**MI&CT ESERVICE NOTE
SN07082410a**

Subject: Global Table Stain on Side Leg Panel

Effectivity: VCT 64, VCT32 and RT16

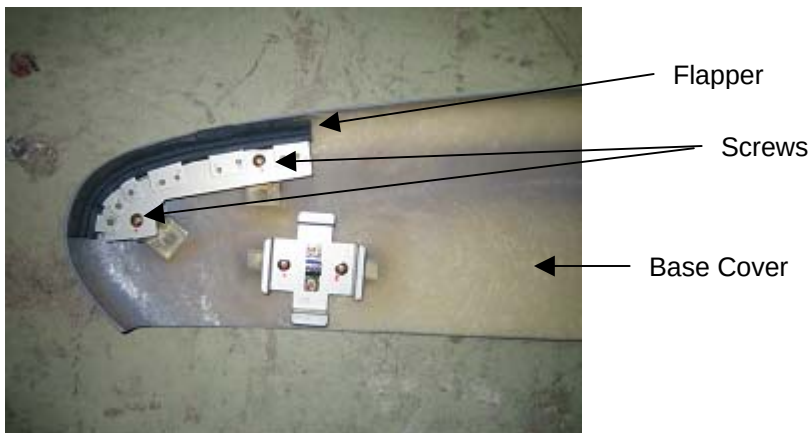
It is commonly seen that the Flappers installed on Table Base Covers make blue stain on Table Side Leg Panels as Table moves up and down over a period of time.

Engineering decided to remove the Flapper from the Base Cover as it is installed on the cover just for cosmetic reason.

This change will be applied to the forward production as soon as supplier's preparation is completed. For installed base, remove the Flapper as needed. The Flapper can be removed by removing two screws.
